# Access Compliance Report

## Public Rights-of-Way

### (Curb Ramps)

Intersection ID: 17126	Main Street: MISSION_HILLS_RD	Cross Street: TEABERRY_CT	Location: NE
ADA ID: 00D0BE5CDB92	Ramp Type: PerpDiag	Initial Pass/Fail: Fail	Overall Compliance: No
			Severity Score: 13.75

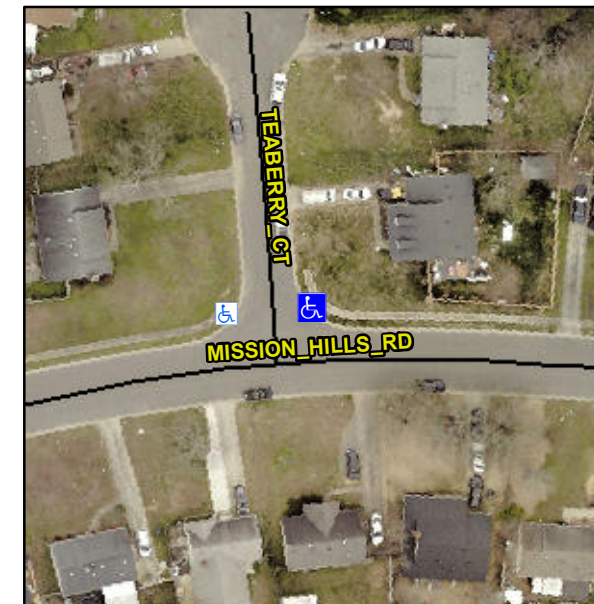
**Not Found, R304.2.2, R304.5.3**

Compliance	Description	Data	Compliance	Description	Data
N/A	Ramp Length (in)	46.0	No	Ramp Slope (%)	9.1
Yes	Ramp Width (in)	48.0	No	Ramp XSlope (%)	2.1
N/A	Flare Type LT	N/A	N/A	Flare Type RT	N/A
N/A	Flare Slope LT (%)	N/A	N/A	Flare Slope RT (%)	N/A
N/A	Flare Traversable LT?	N/A	N/A	Flare Traversable RT?	N/A
N/A	Landing Length (in)	N/A	N/A	DWS Provided?	N/A
N/A	Landing Width (in)	N/A	N/A	DWS Contrast?	N/A
N/A	Landing Slope (%)	N/A	N/A	DWS Length (in)	N/A
N/A	Landing X Slope (%)	N/A	N/A	DWS Full Width?	N/A
N/A	Landing Curb? (Y/N)	N/A	N/A	DWS Offset (in)	N/A
N/A	Shared Landing?	N/A			
N/A	Gutter Ponding?	N/A	N/A	Gutter Slope (%)	N/A
N/A	Gutter Lip Ht (in)	N/A	N/A	Gutter X Slope (%)	N/A
N/A	Painted X Walk1?	No	N/A	Painted X Walk2?	No
	X Walk 1 Direction	To NW		X Walk 2 Direction	To SW
N/A	X Walk 1 Width (in)	N/A	N/A	X Walk 2 Width (in)	N/A
	X Walk 1 Slope (%)	3.6		X Walk 2 Slope (%)	0.0
	X Walk 1 X Slope (%)	0.6		X Walk 2 X Slope (%)	4.2

**Remove & Replace Curb Ramp With Two New Directional Ramps or Equivalent.**
